December 1960

AUTO-VAP MOPED - LIGHTING

SERVICE DEPARTMENT.

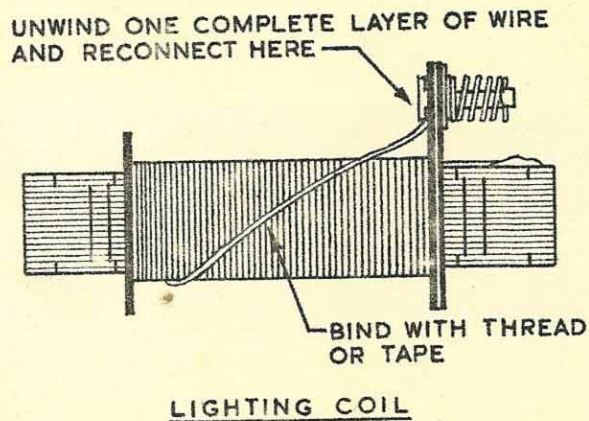
If persistent bulb blowing is experienced with either the head or tail lamp bulbs and assuming that the trouble is not being caused by loose bulbs or fittings, we suggest that the following modification be made to the lighting coil:

- (1) Remove the main feed wire from the terminal post. Remove the lighting coil from the Magneclair assembly, this is held in position by two spring clips which can easily be prised away from the coil with a screwdriver.
- (2) Cut the wire at the spring terminal post connection and unwind one complete layer of wire. Cut the wire that has been unwound from the coil leaving sufficient length to connect up to the spring terminal post.
- (3) Scrape the shellac covering from the end of the wire and pass the wire through the terminal post.
- (4) Bind the winding with a few turns of thread or insulated tape to prevent slackening of the winding.
- (5) Replace the coil and reconnect the main feed wire to the terminal post.
